From: Virginia Taylor-5133
To: kerrigan.engineers@xtra.co.nz
Sent: Monday, July 14, 2008 2:32 PM
Subject: Re U080536-Flaxbourne Motels Limited

ENGINEERING REPORT

Site Evaluation for Onsite Waste Water Disposal
at State Highway 1, Ward, Marlborough

U080536 – Flaxbourne Motels Limited – State Highway 1, Ward

SITE PLAN

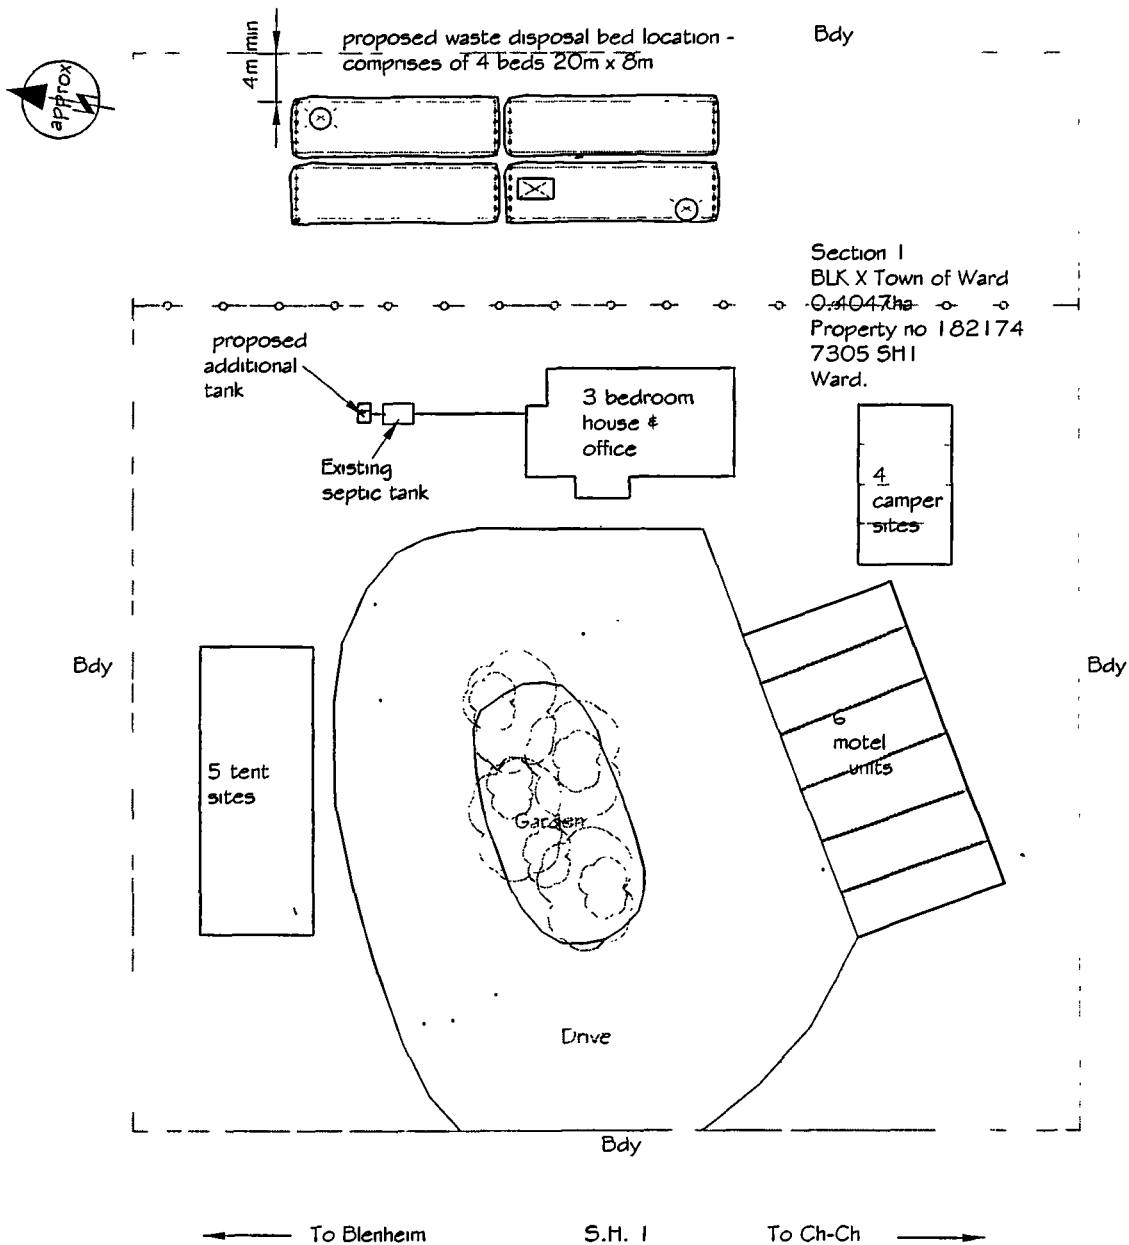
In Jenny's absence, the report has been assessed by Glen Parker who has requested the following:
Please provide information as how the figure supplied for load capacity required per day was calculated, specifying the bed capacity of the motel units and number of people per tent site and campervan site.

Attached is my calculation sheets with the information you are after.

Please note though that the numbers provided in my resource consent report are not a design. Hence the construction maybe based on differing numbers depending on the constructed design.

SITE PLAN scale 1:750

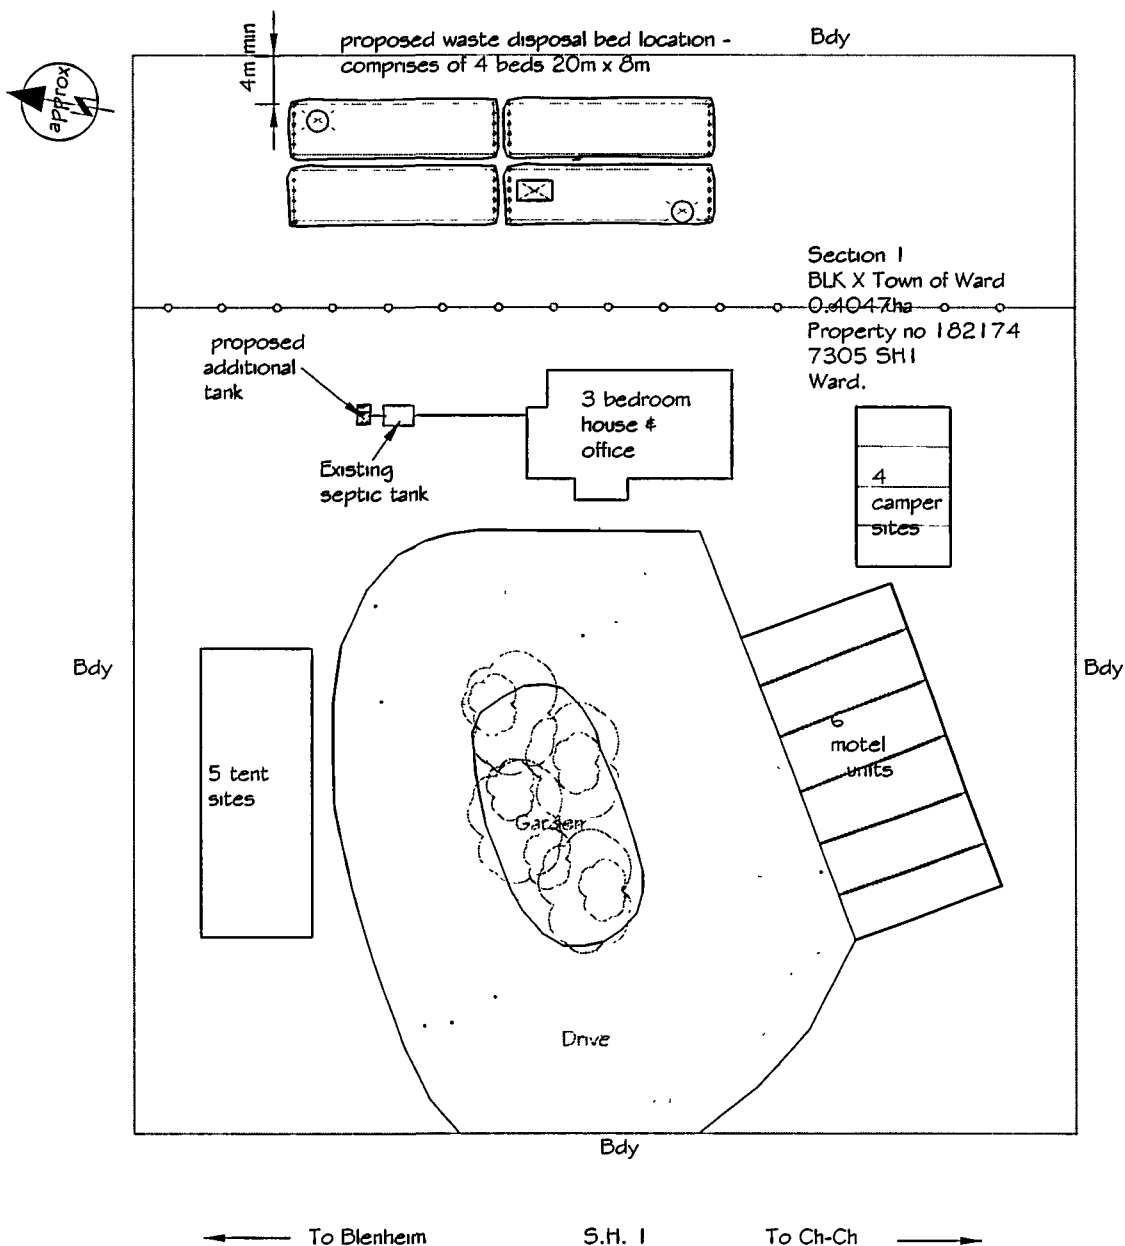
1. The discharge portion of the application has been reviewed by Council staff and their assessment has concluded that discharge consent is required. Please provide a soil and site assessment and design report together with an AEE evaluation for the activity.
2. Please provide a detailed site plan showing all connections discharging to the system. This should include all the details of the existing system and all details of what is proposed for the new system.
3. As requested in my letter to the applicant on 6 June 2008, please provide information as to the volume that will be discharged from campervans and where within the site is the facility for discharging campervan holding tanks?
